Additions and Corrections to the Operating Instructions

Installation in a downward vertical position

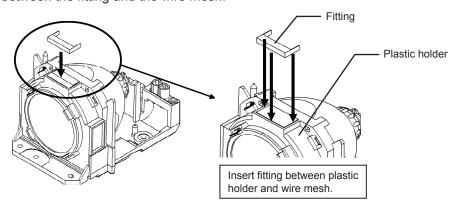
When installing the projector in a downward vertical position, <u>please ensure to attach the supplied fittings to all lamp units.</u>
Without the fittings, the lamp life may be shortened.

When installing the projector other than in a downward vertical position, remove the fittings.

- ① Remove the lamp unit from the projector, following the "Procedure of lamp unit replacement" (Page 115) of the Operating Instructions.
- ② Insert the fitting into the gap between the plastic holder and the wire mesh as shown in the figure below.
- * Leave no gap between the fitting and the wire mesh.

③ Install the lamp unit into the projector, following the "Procedure of lamp unit replacement" (Page 115) of the Operating Instructions.
